HISTORIC DISTRICT REVIEW EXHIBIT LIST

Applicant: Bistro St. Michaels

Property Address: 403 S. Talbot Street

Application Number: HD-21-727

OUTDOOR DINING

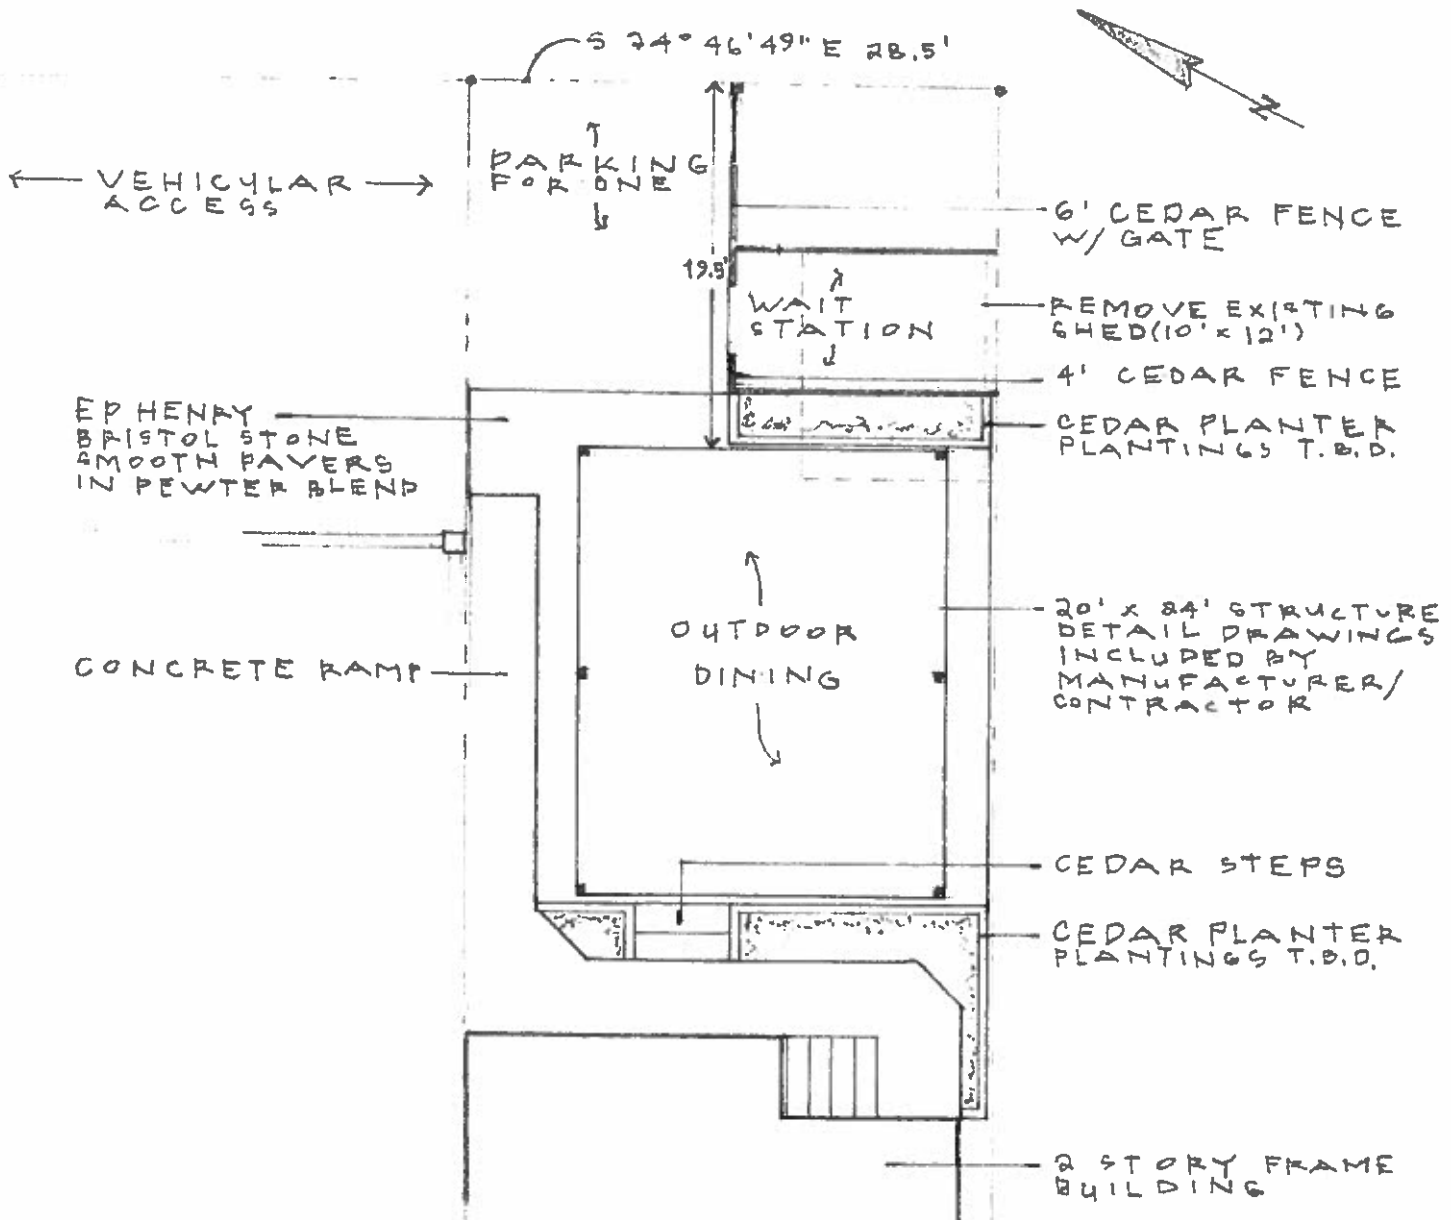
The applicant is proposing to install outdoor patio with pergola type structure, fence, and remove shed. Currently under site plan review to ensure complaint with zoning code requirements such as setbacks, lot coverage, stormwater, and outdoor seating. Fence cannot exceed 6' and structural side must face inwards towards property. No other zoning issues noted at this time.
